Final Solar Ponds Plume Decision Document

RF/RMRS-98-286.UN

**Major Modifications to the
Final Proposed Interim Measures/Interim Remedial Action
Decision Document for the Solar Evaporation Ponds
Operable Unit 4, 1992**

Response to City of Westminster Comments on the Draft Solar Ponds Plume Decision Document
received June 3, 1999

Figure 5-2
Collection Trench Details

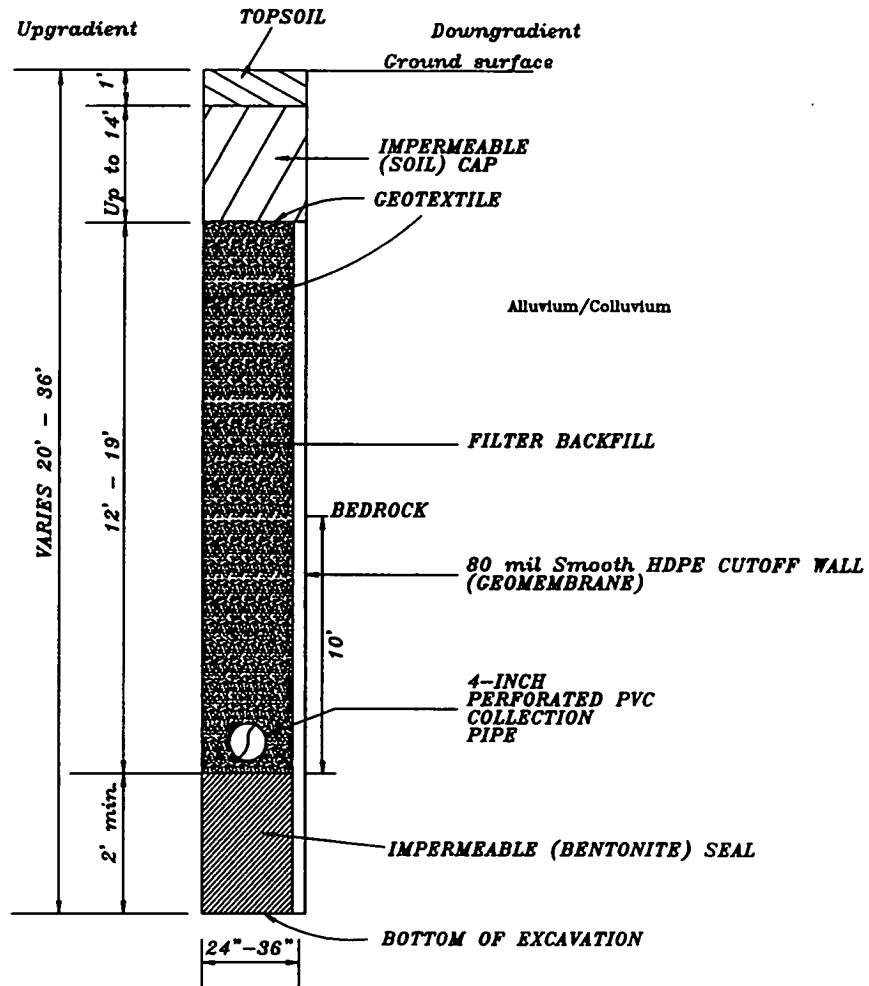
Comment: The Department of Energy has acknowledged that building an 850 foot long collection system with passive flow-through treatment cells containing reactive iron will not fully cover the extent of the plume and a large quantity of the plume flow will bypass the barrier. The Decision Document does not provide adequate information as to what amount of the groundwater plume flows will not be collected by the barrier but will flow into Walnut Creek without treatment.

Comment: We request that this information as well as documentation regarding performance monitoring, methods for replacing the reactive barrier media, as well as the ability of the barrier to withstand a 100 year flood be included in the final document.

Comment: At least two reactive treatment cells should be operated in series to provide a backup treatment should the initial cell fail to remove all the contaminants. A back up cell would also be useful when one of the barriers require maintenance. Westminster also requests that monitoring include routine effluent testing of the first treatment cell to detect breakthrough and allow for replacement of the treatment media in the first cell before the second cell can be compromised.

Response: Problems with bypass are more notable for the existing ITS rather than the barrier system proposed in the Decision Document. Because the drains associated with the ITS were not entirely keyed into bedrock, an estimated 200,000 gallons bypass the system annually. The collection trench will penetrate 10 feet into the weathered bedrock, thus minimizing any potential for underflow. The barrier extends southwest on the north side and, a well cluster to the north of the barrier will be installed to provide additional data and for performance monitoring purposes.

Response: The performance monitoring section (Section 5.5) of the Decision Document has been expanded. Specifically, the section now states:

As indicated in the above discussion, "decision criteria" with respect to when the treatment media will be replaced has been added to the performance monitoring section of the Decision Document. As stated, the method of replacement will be to dig up the spent treatment media and replace it with new treatment media.

Response: Two treatment cells will be used; however, the cells are not considered redundant. The first cell will be filled with a mixture of organic media (sawdust) to act as a carbon source to induce denitrification and iron to remove the uranium by chemical reduction. Nutrient mulch, which will increase the denitrification rate, may also be added to the iron/sawdust treatment media. The second

cell will be filled with 100 percent granular activated iron aggregate. Results from the treatability studies indicate that this configuration will effectively remove uranium from solution to less than 2 ug/L. The nitrate-N removal efficiency is approximately 13 mg/L/day for the first cell (iron/sawdust) and microbial denitrification will also likely continue in the iron treatment cell because of the transport of dissolved organic carbon from the first cell. This will further reduce the nitrate concentrations. As stated in the response to the previous comment regarding performance monitoring, influent and effluent concentrations for the treatment system will be measured.
